PCD Project Number: PPR-21-17

WATERMARK AT AKERS
GRADING EROSION CONTROL PLAN

Grading & Erosion Control Plan_V1.pdf Markup Summary

C2.3

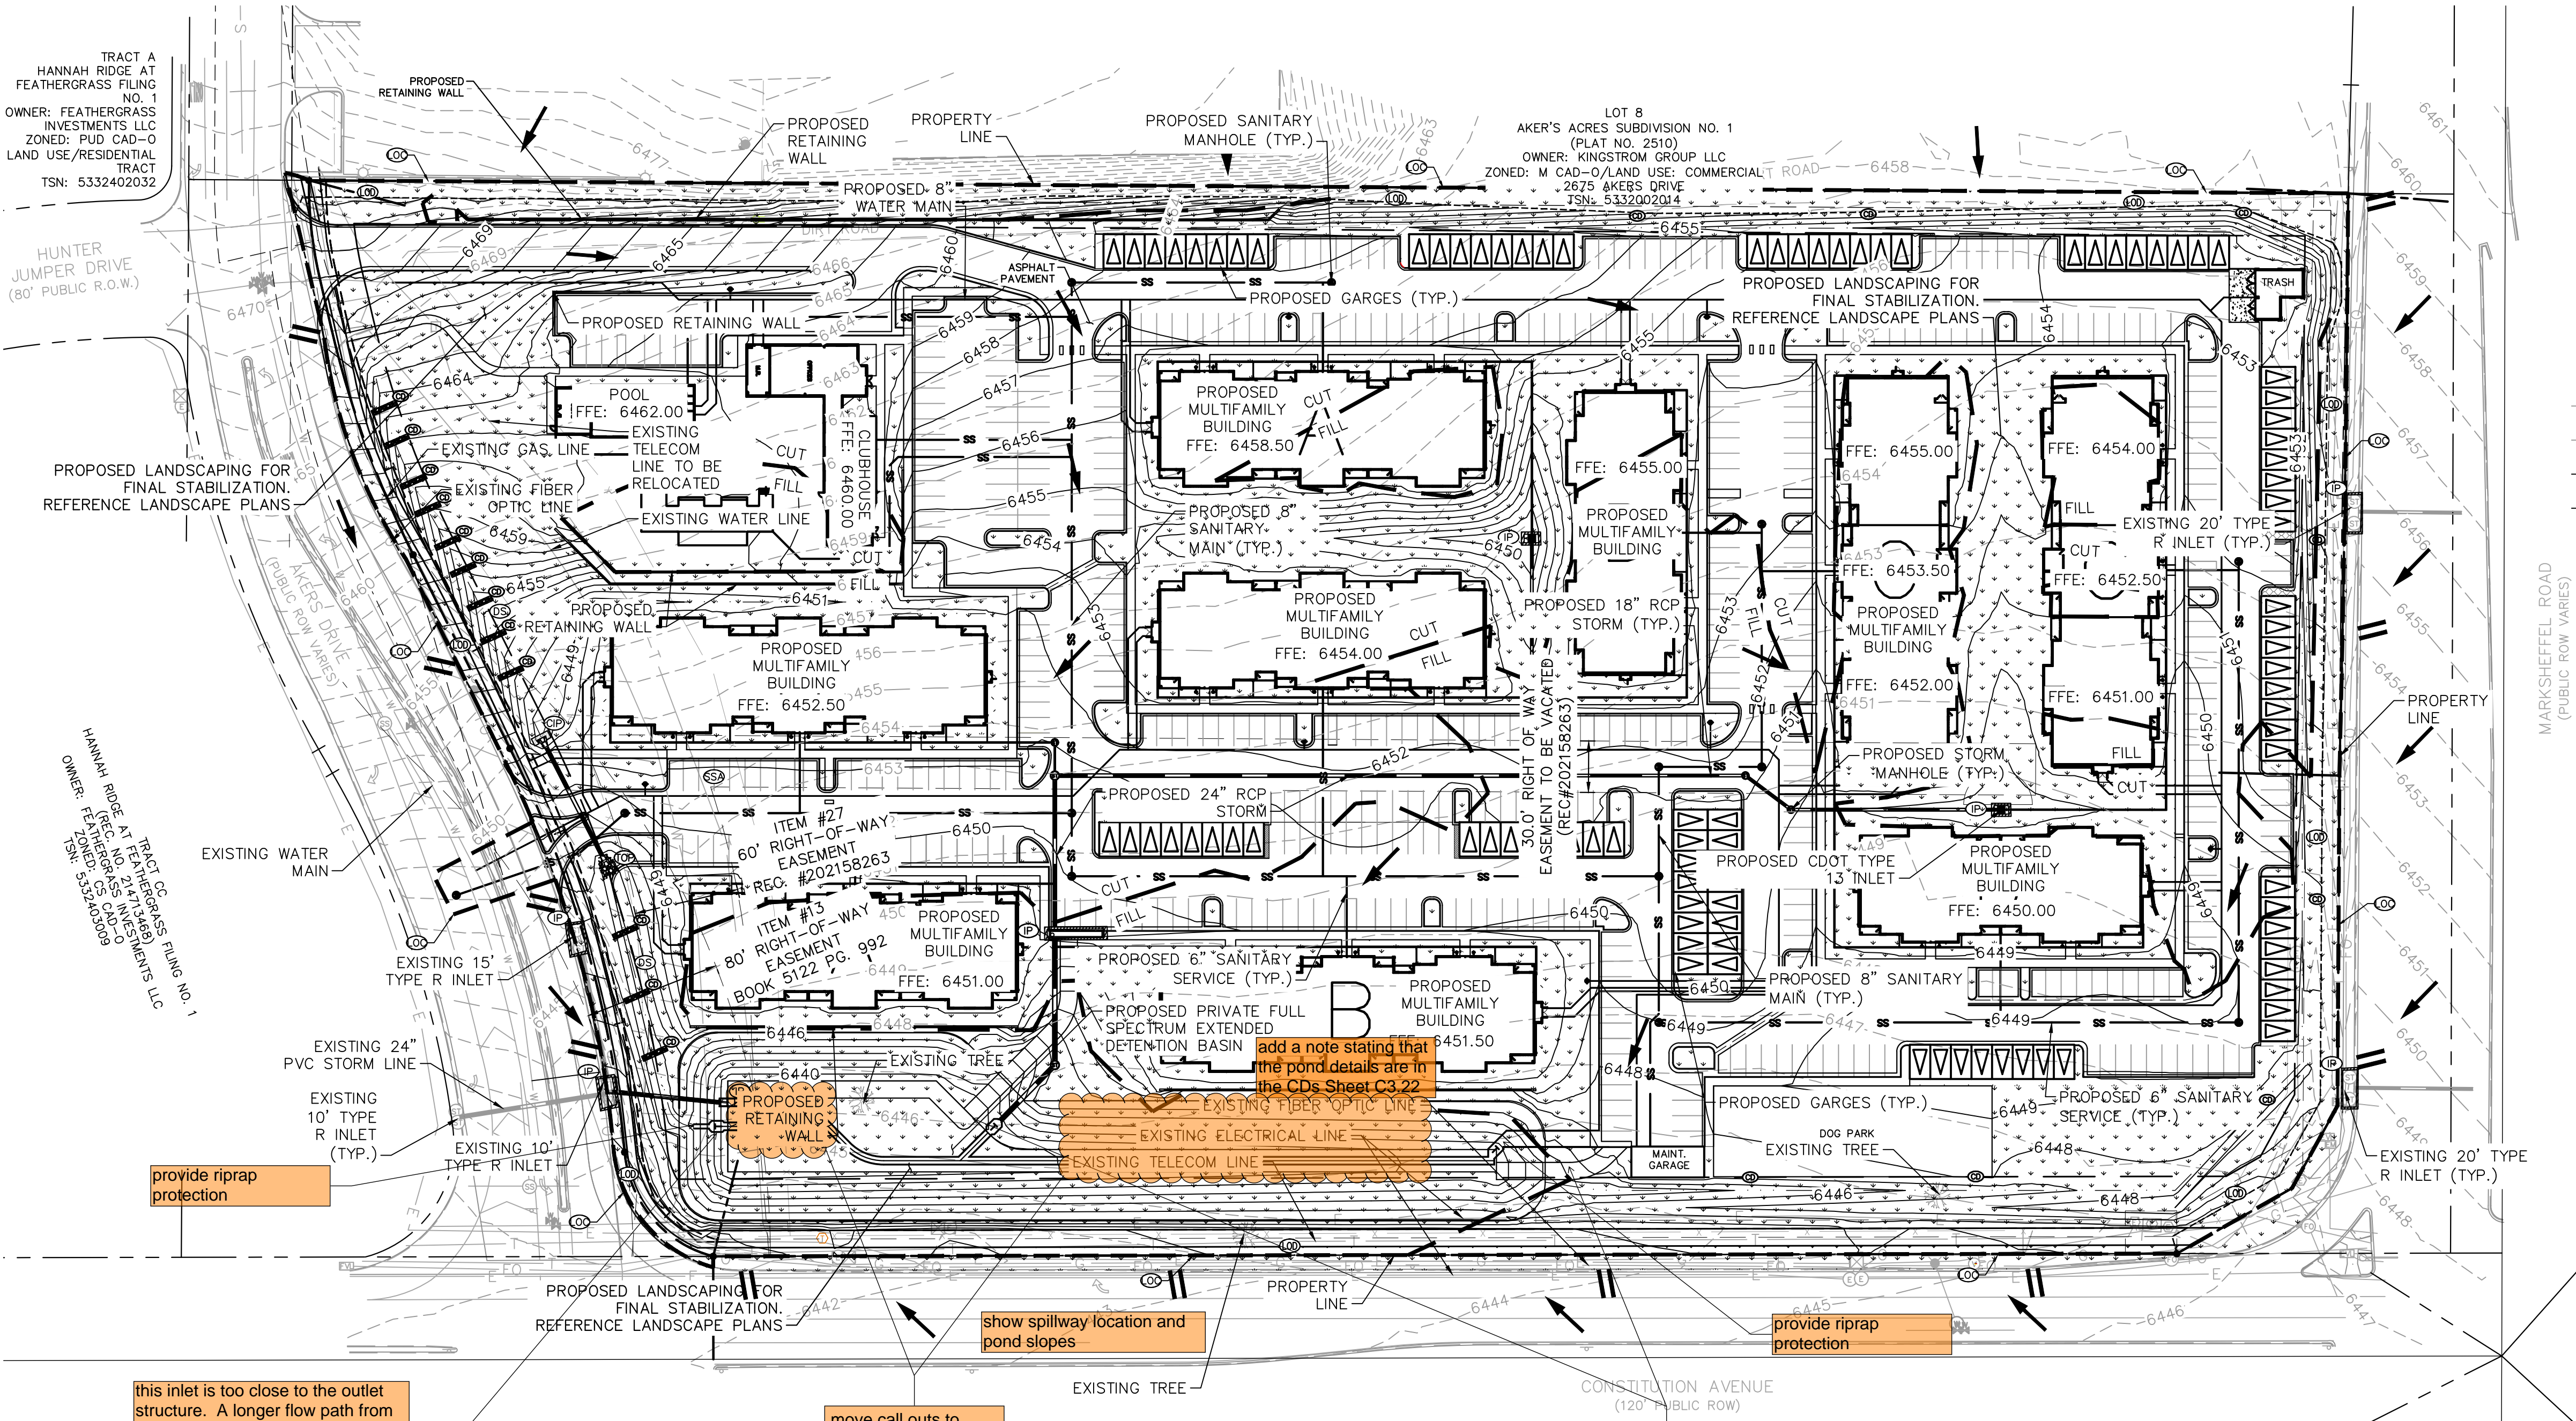
Add a note stating that there will not be any dedicated asphalt / concrete batch plants onsite.

add a note stating that the pond details are in the CDs Sheet C3.22

show spillway location and pond slopes

move call outs to show trickle channel

provide riprap protection

provide riprap protection

Add a note stating that there will not be any dedicated asphalt / concrete batch plants onsite.
